Tesla, Inc. Service Bulletin		Replace Occupant Classification System (OCS) of Front Passenger Seat while Servicing Subcomponents	
SB-23-20-002 June 8, 2023		R4			
Classification		Section/Group		Mobile Service	Configuration
Repair Bulletin		20 - Safety and Restraint		Can Perform (where permitted)	All
Model Year	Model	Country/Region		Build Location	
2017 - 2023	Model 3, Model Y	North America, Asia Pacific		Fremont, Giga Austin	
The model(s) and model year(s) listed are a general approximation of the affected VIN list. Refer to the VIN/Bulletin Tracker or Customer/Vehicle profile to determine applicability of this bulletin for a particular vehicle.

This Service Document supersedes SB-23-20-002 R3, dated 4-Apr-23. This new revision, R4, adds front passenger seat module connector port and resistive occupancy sensor routing direction. Each content change is marked by a vertical line in the left margin. Discard the previous version and replace it with this one.

Figure 5

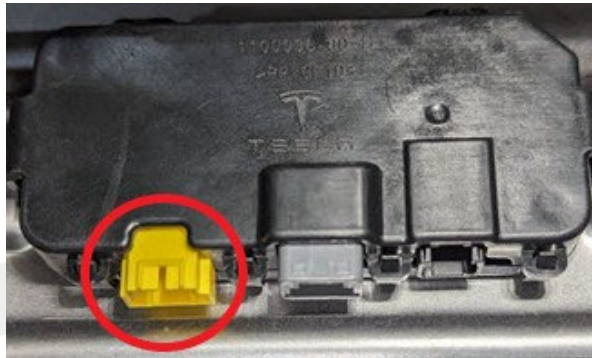
7. Replace the passenger seat harness with revised part number 1489060-93-F or later (refer to Service Manual procedure 17101802; [Model 3](#), [Model Y](#)). While installing the new seat harness:
- Check the passenger seat module female connector (yellow port) to see if it was dislodged or misaligned during the removal of the old seat harness (Figure 5). If the connector was dislodged or misaligned, press firmly against the connector until it seats back into place.
